Access Compliance Report

Public Rights-of-Way

(Curb Ramps)

Intersection ID: 52313	Main Street: LUPINE_CT	Cross Street: SNOWBELL_CT	Location: SE
ADA ID: 1ADCF649023C	Ramp Type: PerpDiag	Initial Pass/Fail: Pass	Overall Compliance: No
Codes/Mitigation Info/Possible Solution			Severity Score: 20
			Field Measurements/Component Compliance

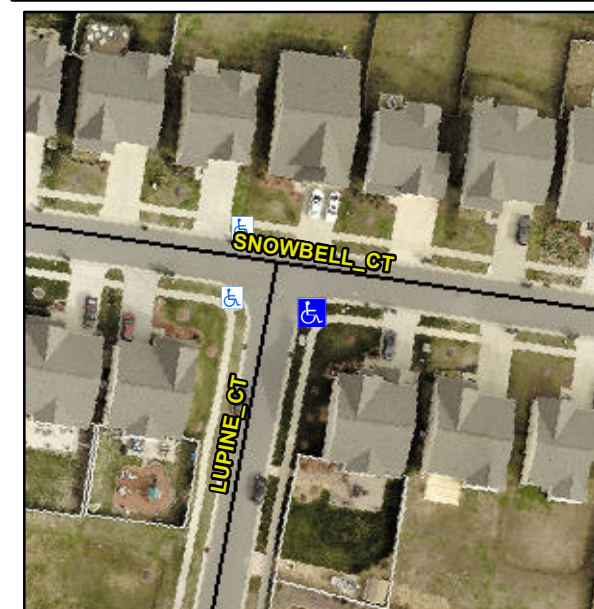
Not Found, R304.5.3, R305.2, R302.7, R302.7.2, R304.5.4

Compliance	Description	Data	Compliance	Description	Data
N/A	Ramp Length (in)	79.0	Yes	Ramp Slope (%)	6.6
Yes	Ramp Width (in)	48.0	Yes	Ramp XSlope (%)	2.0
N/A	Flare Type LT	Sloped	N/A	Flare Type RT	N/A
N/A	Flare Slope LT (%)	0.7	N/A	Flare Slope RT (%)	3.0
N/A	Flare Traversable LT?	No	N/A	Flare Traversable RT?	No
Yes	Landing Length (in)	48.0	Yes	DWS Provided?	Yes
Yes	Landing Width (in)	52.5	Yes	DWS Contrast?	Yes
Yes	Landing Slope (%)	1.9	Yes	DWS Length (in)	24.0
No	Landing X Slope (%)	2.8	Yes	DWS Full Width?	Yes
N/A	Landing Curb? (Y/N)	No	No	DWS Offset (in)	5.0
N/A	Shared Landing?	No			
No	Gutter Ponding?	Yes	No	Gutter Slope (%)	7.3
No	Gutter Lip Ht (in)	2.0	No	Gutter X Slope (%)	2.2
N/A	Painted X Walk1?	No	N/A	Painted X Walk2?	No
	X Walk 1 Direction	To NE		X Walk 2 Direction	To NW
N/A	X Walk 1 Width (in)	N/A	N/A	X Walk 2 Width (in)	N/A
	X Walk 1 Slope (%)	2.6		X Walk 2 Slope (%)	0.8
	X Walk 1 X Slope (%)	3.0		X Walk 2 X Slope (%)	0.1

N/A	Ramp inside XWalk1?	N/A	N/A	Ramp inside XWalk2?	N/A
	Road Slope (%)	0.4	N/A	Clear Space?	Yes
	Road X Slope (%)	0.0	N/A	Clear Space to XWalk (in)	N/A
Yes	Any Obstructions?	No	Yes	Storm Grate/Utility Hazard?	No
	Obstruction Type			Storm Grate/Utility Type	
		N/A			N/A
			Yes	Surface Condition? (G/P)	Good

Remove & Replace Curb Ramp With Two New Directional Ramps or Equivalent. Remove & Replace Gutter.
